UNITED STATES PATENT AND TRADEMARK OFFICE

Office Action Summary	Application No.	Applicant(s)	
	10/526,971	KATZ, ANDRE	
	Examiner	Art Unit	
	Mary A. Davis	3748

DETAILED ACTION

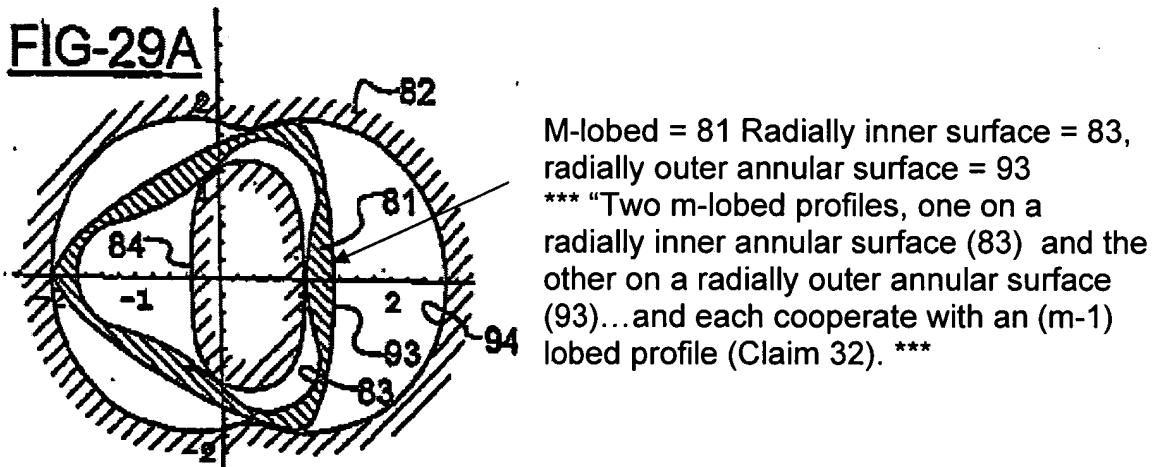
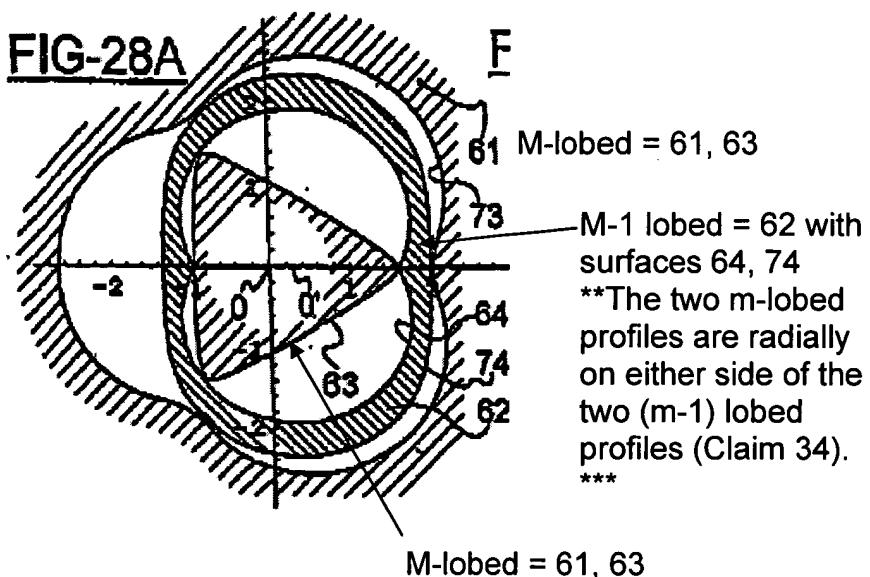
21. With regards to the 112 2nd paragraph rejection of claim 34 contradicting claim 32, and that claim 34 should not depend from claim 34, the applicant is not clear on why claim 34 would contradict claim 32. The Examiner has reproduced Figures 28A and 29A. Claim 32 recitations to: "two m-lobed profiles, one on a radially inner annular surface and one on a radially outer annular surface" is shown below as it relates to Figure 29A. This limitation in claim 32 does not describe Figure 28A, since the profile on the radially inner annular surface and on radially outer annular surface are a "m-1 lobed" and not an "m-lobed" as specified in the limitation of claim 32. Claim 34 recitation to "the two m-lobed profiles ... are radially on either side of the two (m-1) lobed profiles" is shown below as it relates to Figure 28A. The limitation of claim 34 does not describe Figure 29A and is describing Figure 28A, as shown below. Claim 32 appears to be describing Figures 29A-F, and claim 34 is describing Figures 28A-F. How can the two m-lobed profiles be on a radially inner annular surface and one a radially outer annular surface (claim 32) while also be radially on either side of the two (m-1) lobed profiles (claim 34)? Therefore, the Examiner has suggested that claim 34 is not dependent on claim 32.

Marked up Figure 2 of TAYLOR ET AL.

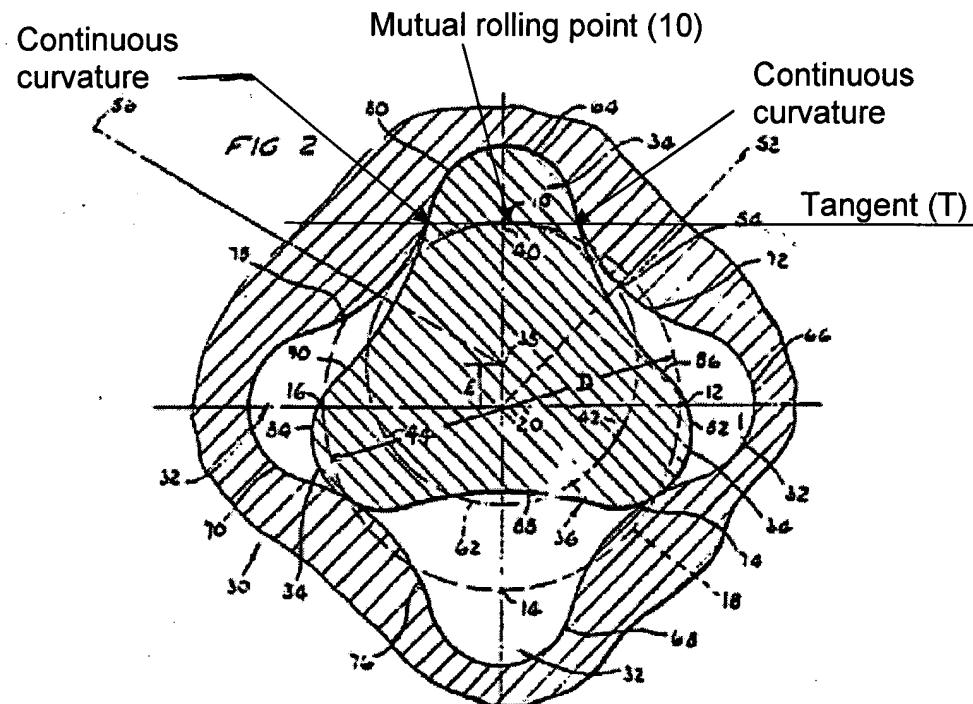
24. Applicant further argues that the curvature is discontinuous at the contact point since the curvature changes from concave to convex and that the embodiments of TAYLOR ET AL could not operate. The Examiner disagrees with the applicant's argument, see marked up Figure 2 that shows that the curves are continuous at the contact point. Furthermore, the Examiner disagrees with the conclusion made by the applicant that if the curvature changes from concave to convex that the curvature is not continuous. In addition, the argument with respect to the why TAYLOR ET AL can not operate is not persuasive.

Marked up Figure 18 of BONAVERA.

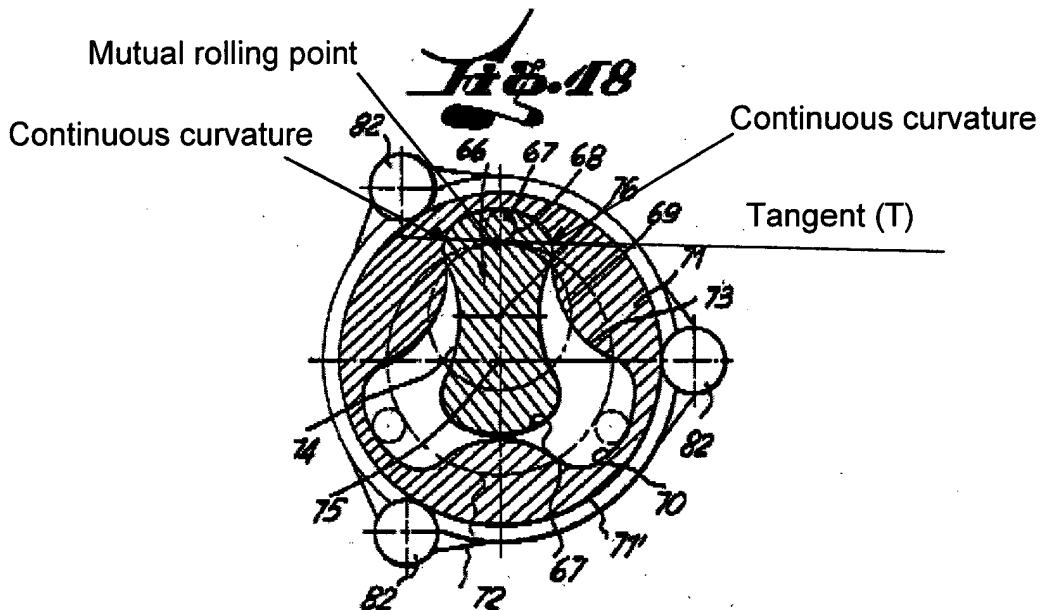
25. With regards to the 103(a) rejection of GRAY in view of BONAVERA and in view of WANKEL, applicant argues that BONAVERA's movement of the profile members is impossible. The Examiner does not find the applicant's arguments persuasive. In response to applicant's argument that the references fail to show certain features of applicant's invention, it is noted that the features upon which applicant relies (i.e., identical curvatures) are not recited in the rejected claim(s). Although the claims are interpreted in light of the specification, limitations from the specification are not read into the claims. See *In re Van Geuns*, 988 F.2d 1181, 26 USPQ2d 1057 (Fed. Cir. 1993). Furthermore, Figure 18 of BONAVERA is marked up below to show that the contact points of the profile members are at the tangent of the pitch circles, which the contact points are on a part with continuous curvature.
